UNITED STATES PATENT AND TRADEMARK OFFICE

APPLICATION NO.	FILING DATE	FIRST NAMED INVENTOR	ATTORNEY DOCKET NO.	CONFIRMATION NO.
09/868,781	04/08/2002	David Horne	DYOUP0215US	6334

Office Action Summary

DETAILED ACTION

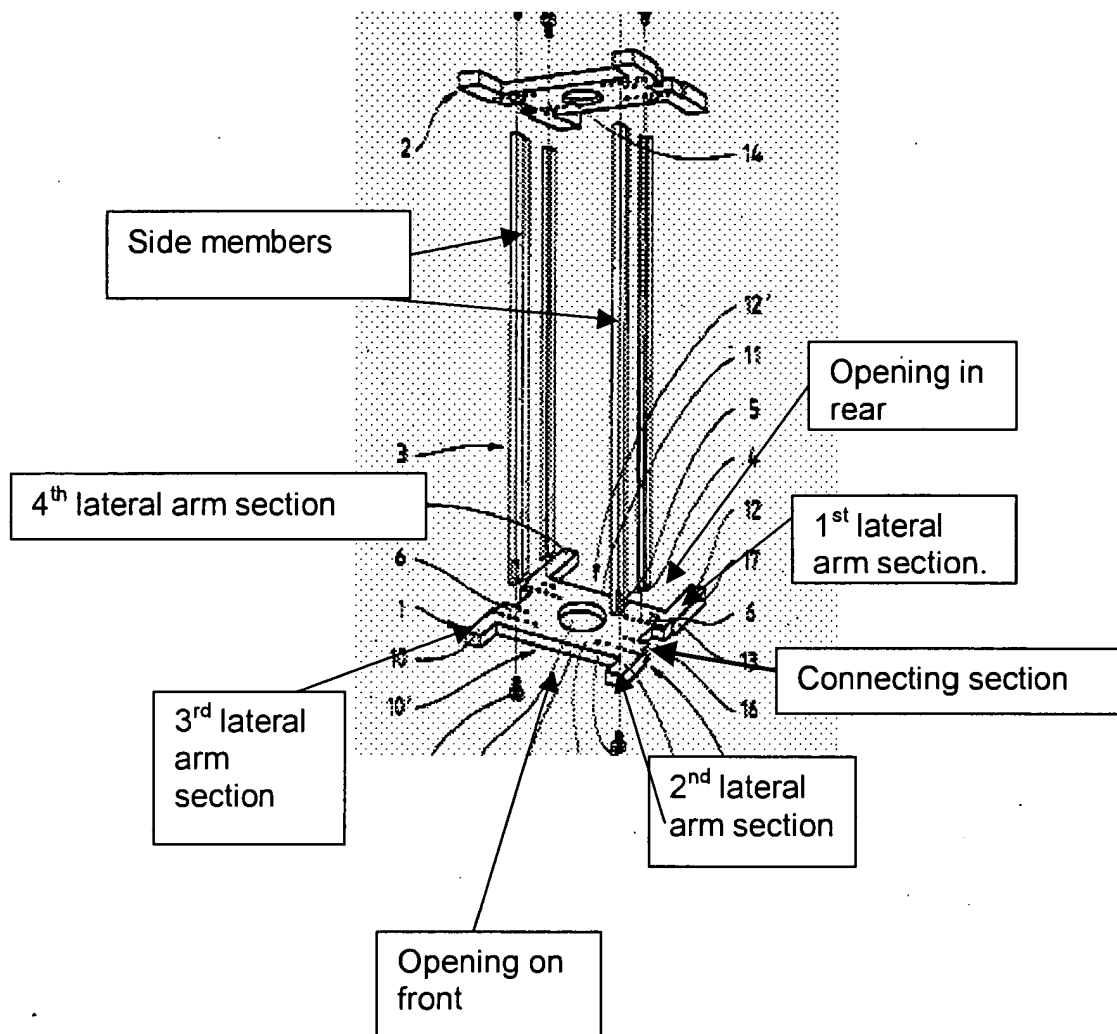
Claim 24 is rejected under 35 U.S.C. 102(b) as being anticipated by Mazura et al (US patent no. 5,488,543). Mazura disclosed all the claimed features of applicant's invention as illustration below.
